90-09-10 TEXAS INSTRUMENTS: Amendment 39-6565. Docket No. 89-ANE-38.

94-21-06 PACIFIC SCIENTIFIC COMPANY, HTL/KIN-TECH DIVISION:  
Amendment 39-9048. Docket 94-NM-73-AD.

Examples of Bolt Head Markings  
**FIGURE 2**

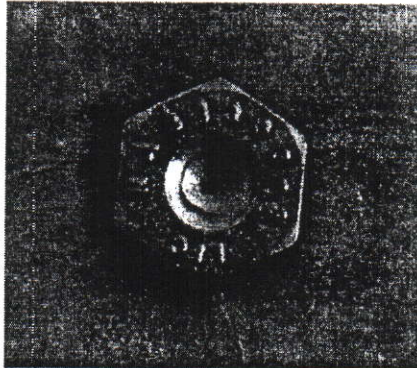
3. Verify the installed bolts are the approved part numbers NAS1303 or NAS6603. If approved bolts are installed proceed to Step 6. Refer to Figure 2.
4. Remove and replace any unapproved bolt part number with an approved bolt part number. Refer to 1124/1124A Westwind Illustrated Parts Catalog, Chapters 54-20-00 and 78-30-00 for proper bolt part numbers.
